PROJECT  
**RESERVE AT THE BALLPARK, PHASE II, AKA REVEL AT THE BALLPARK**  
2885 CRESCENT PKWY  
SMYRNA, GA 30080

| SHEET TITLE  | DOG SPA AND MAINTENANCE PLANS       |
| SHEET NUMBER | A6-30                               |
| COMMENTS     | BUILDING PERMIT RE-SUBMISSION       |

3 DOG SPA SECTION  
SCALE: 1/2" = 1'-0"

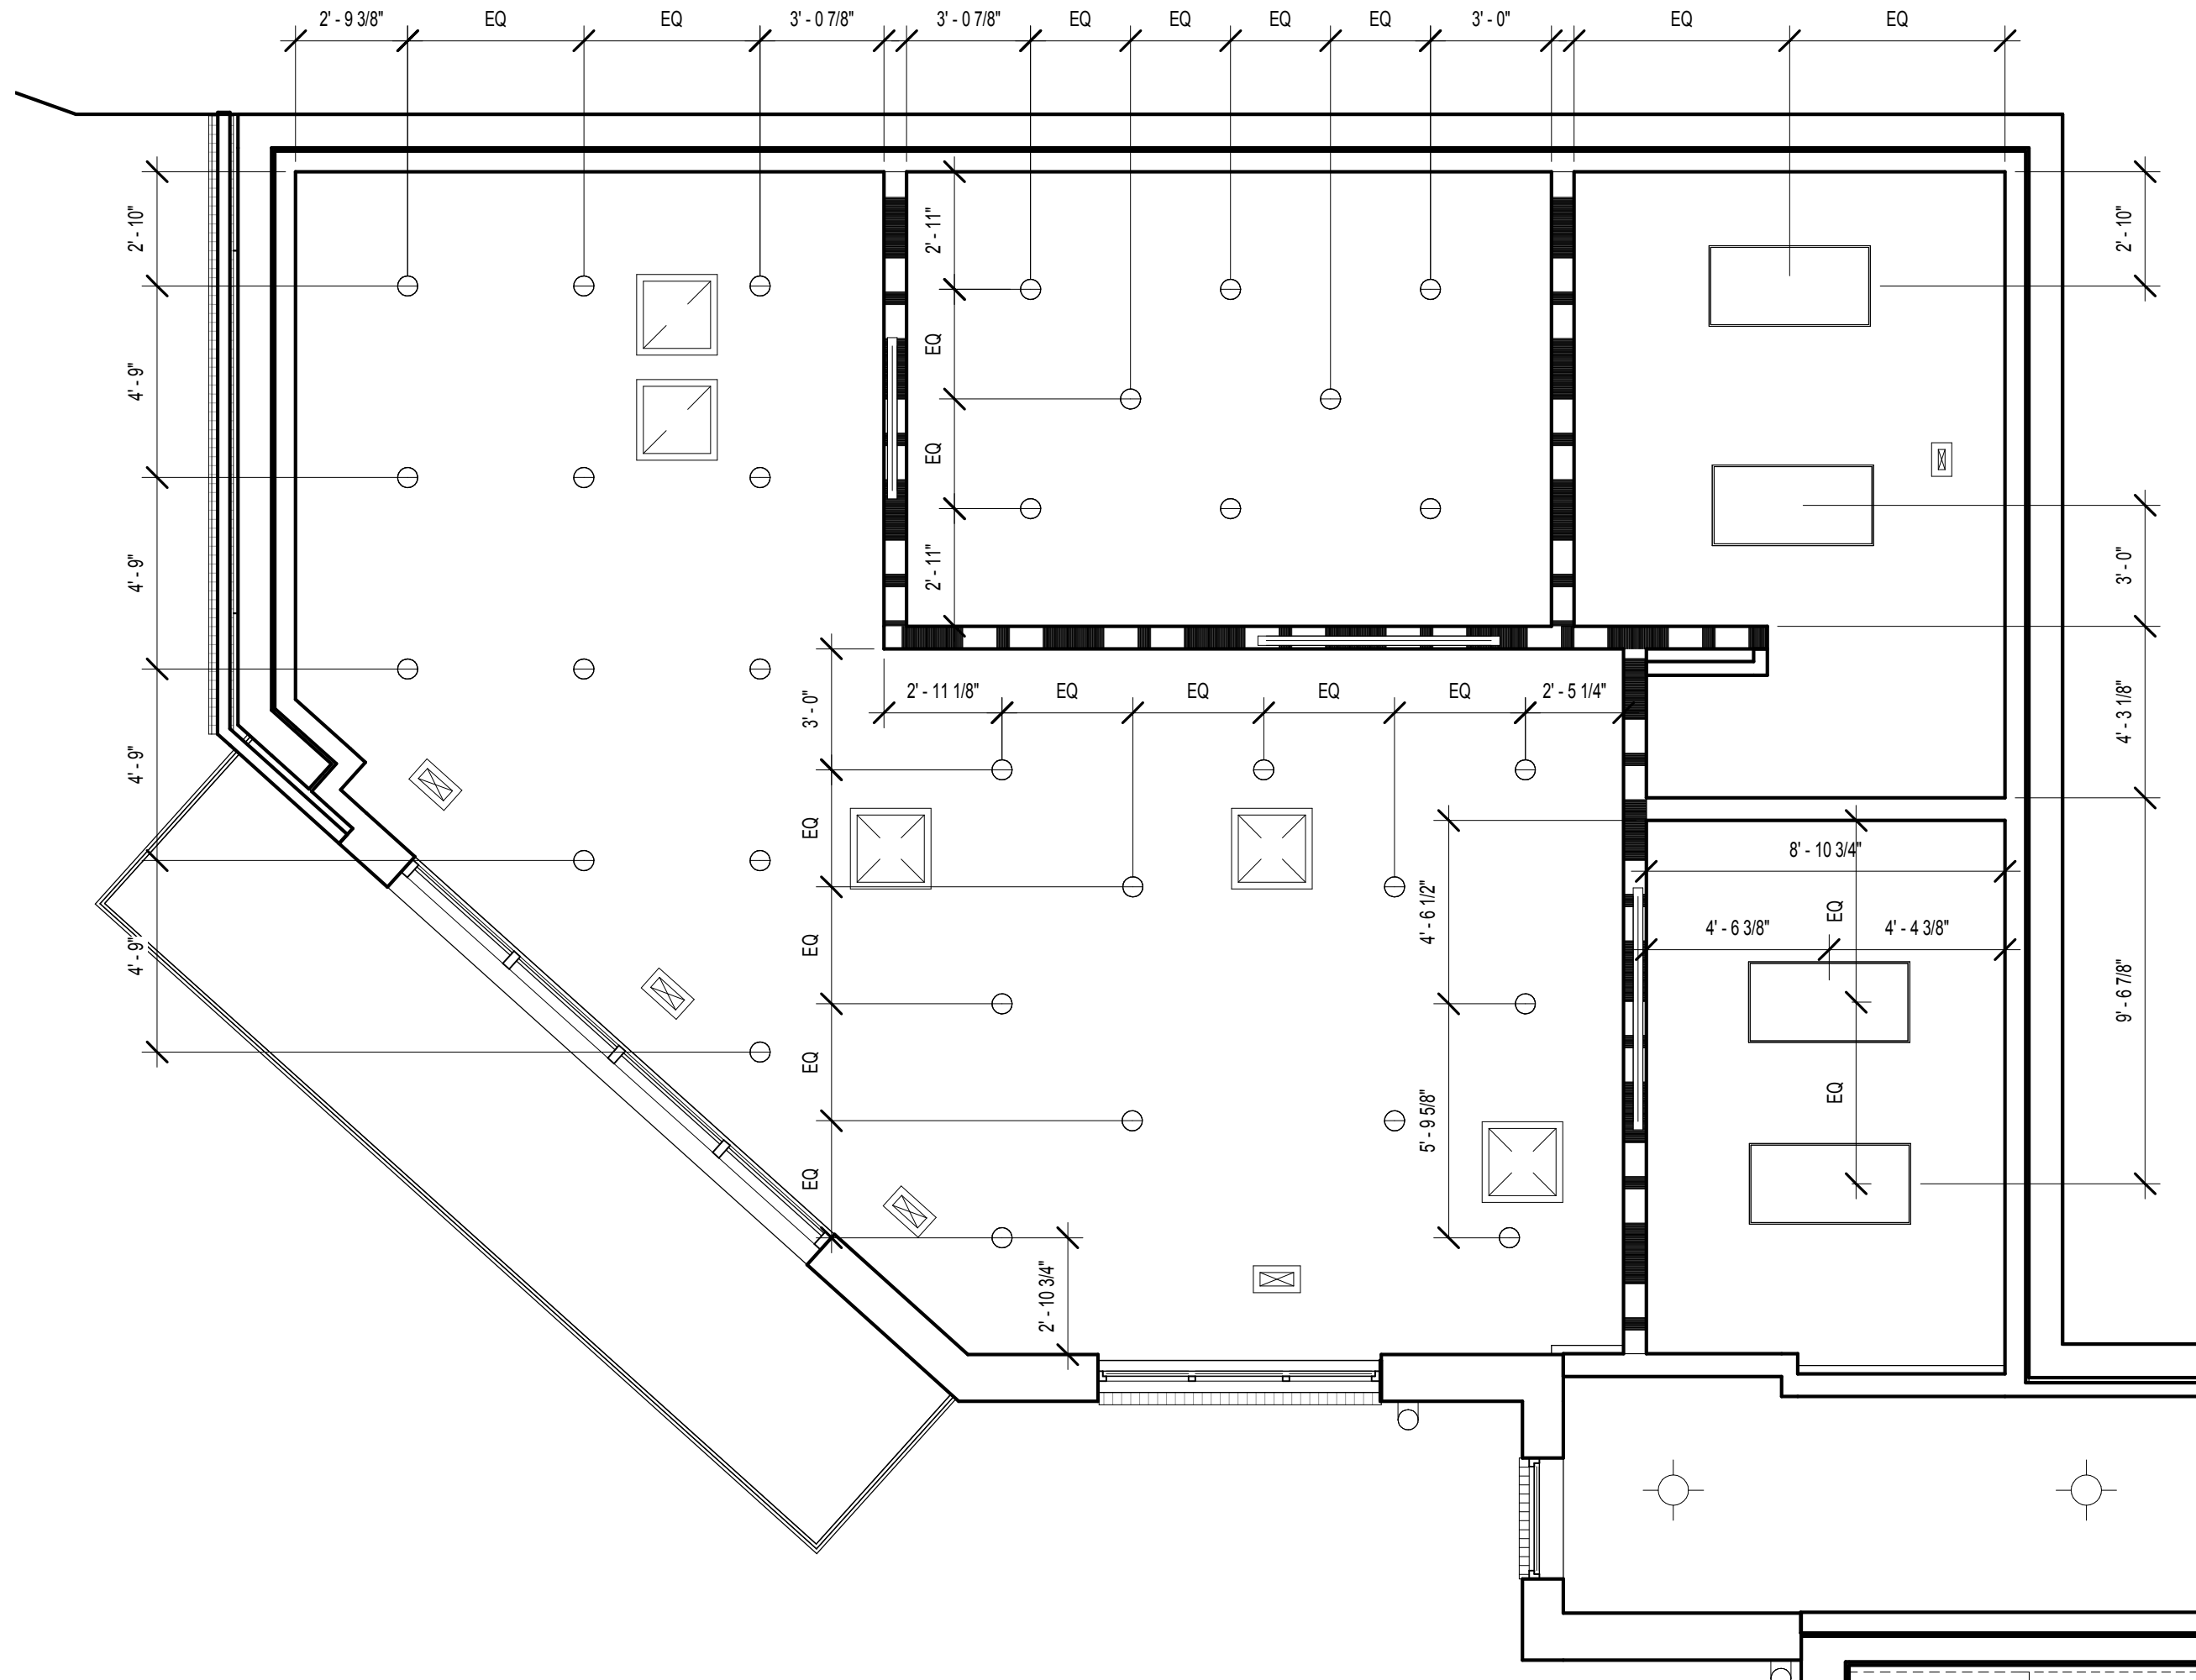
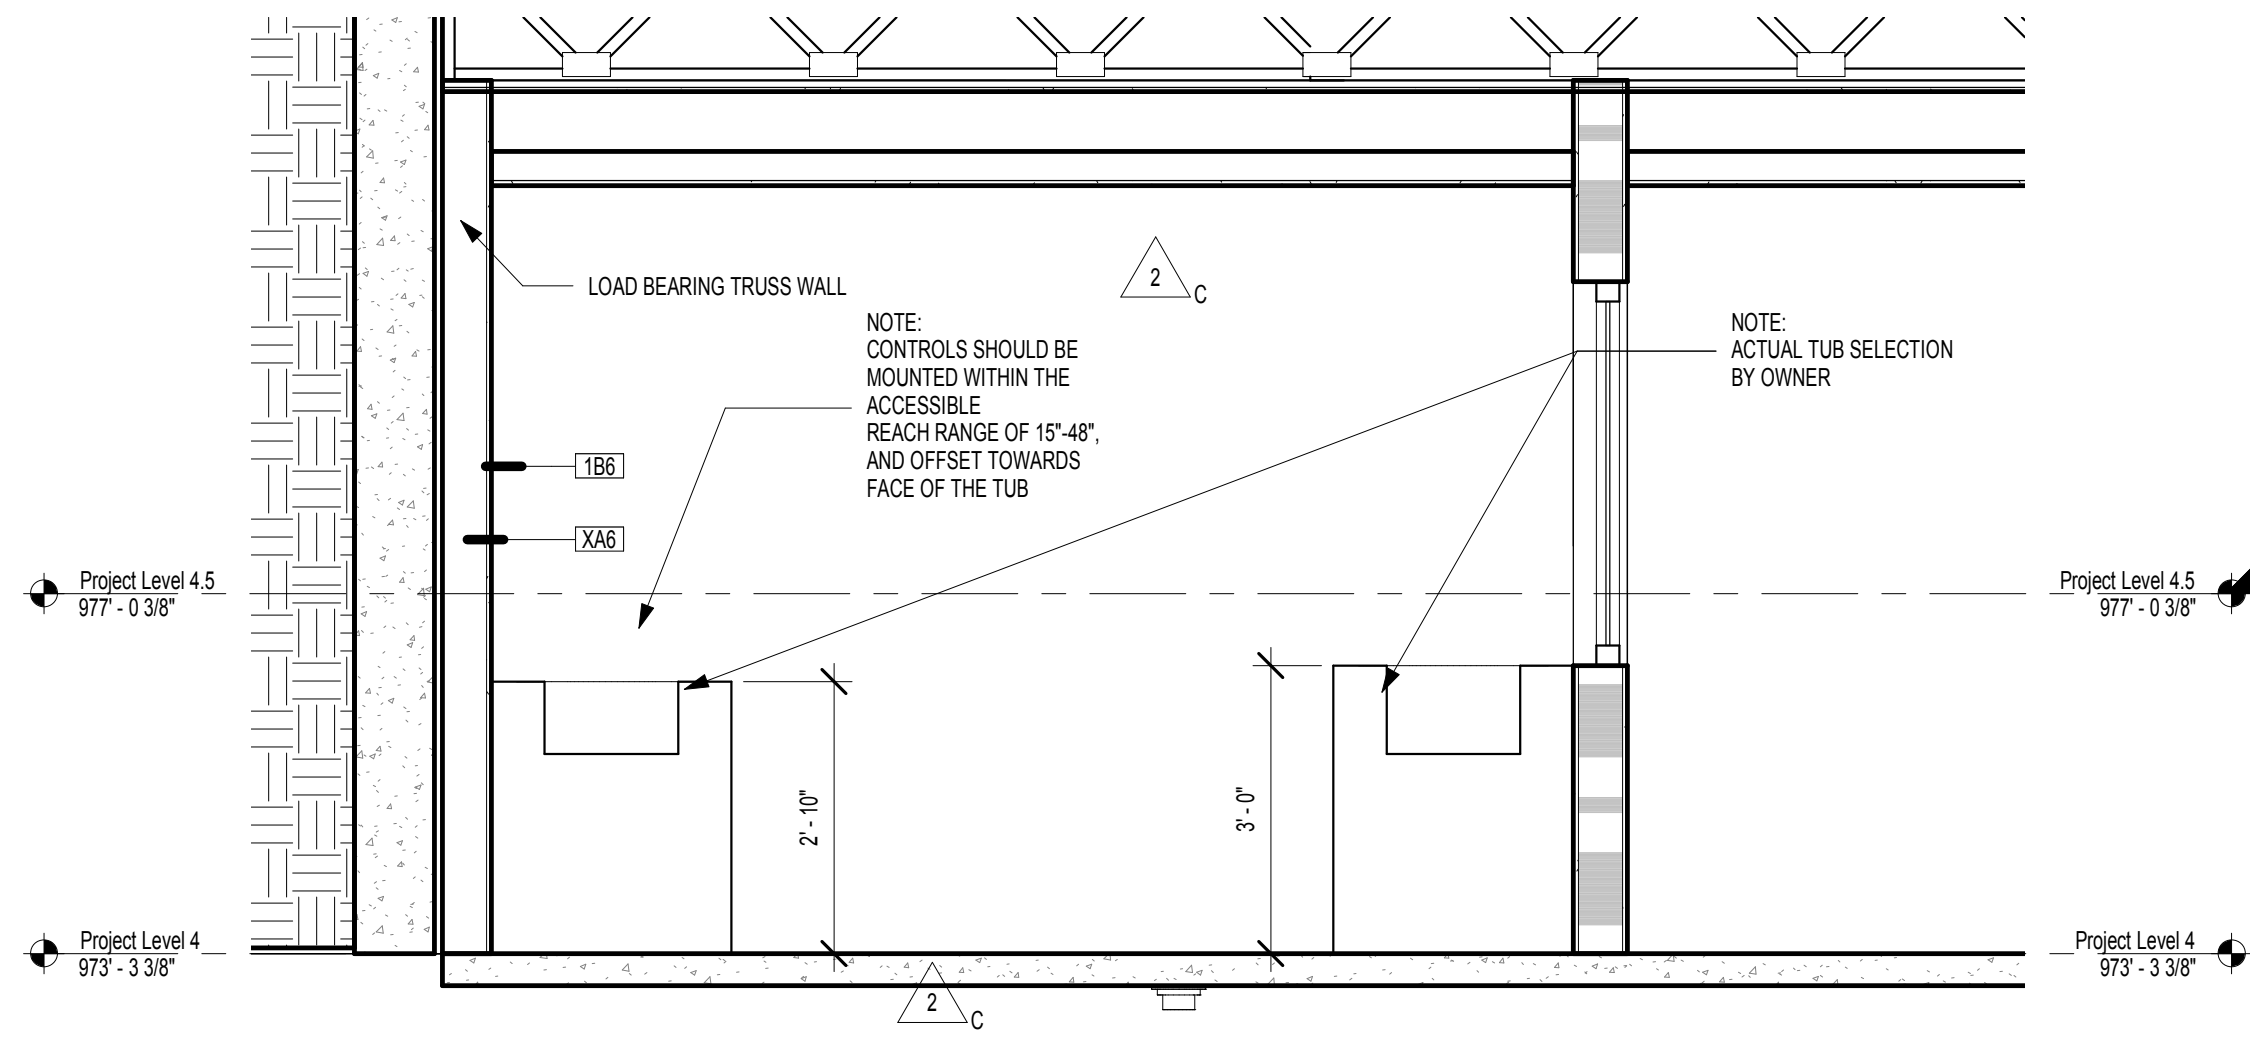
REVISION SUMMARY #2  
A. FIRE RATED DOOR B03 ADDED  
B. ADDED SECTION OF THE DOG SPA  
C. REDUCED TUB HEIGHT OF 34" A.F.F. TO THE TRIM OF THE TUB

1 DOG SPA  
SCALE: 1/4" = 1'-0"

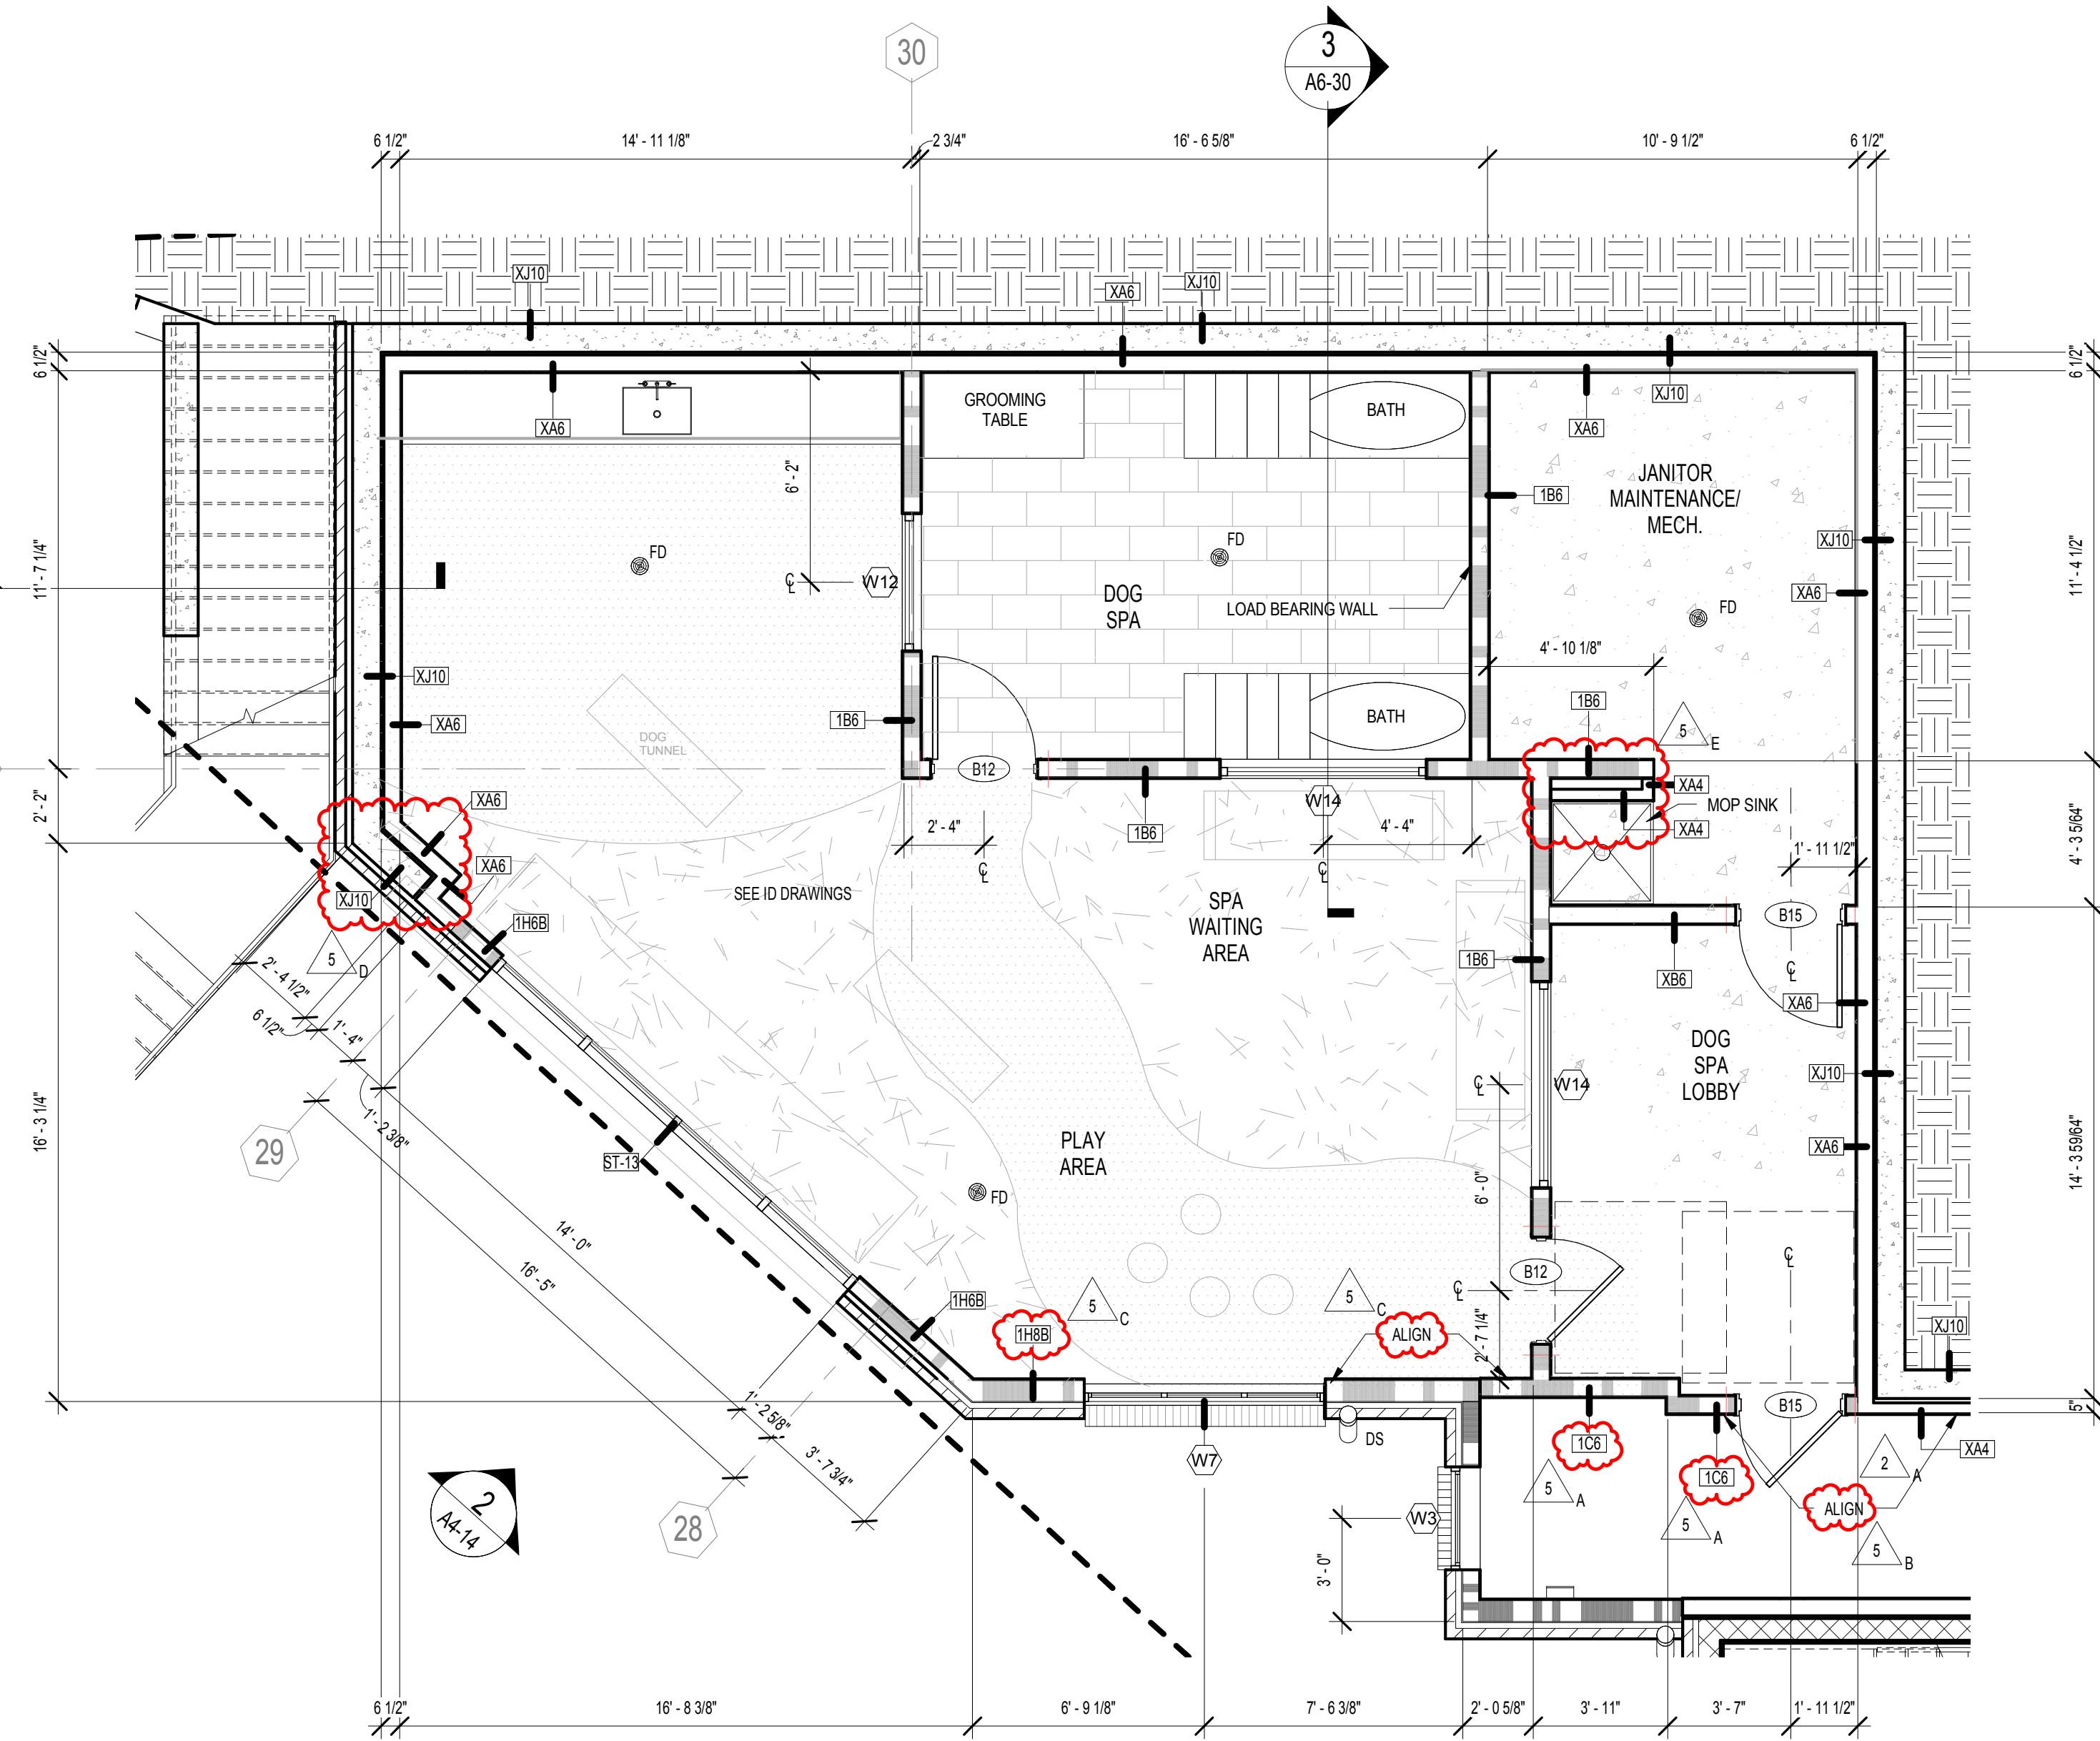
REVISION SUMMARY #5  
A. CHANGED WALLS AT LEVEL 4 ONLY TO BE 6" STUDS PER STRUCTURAL DRAWINGS  
B. MOVED DOG SPA ALCOVE ENTRY TO ALIGN WITH CORRIDOR WALL  
C. CHANGED EXTERIOR WALL TO 8" STUD WALL TO ALIGN  
D. ADDED SECTION OF CIP CONC. WALL  
E. ADDED FURRING WALL
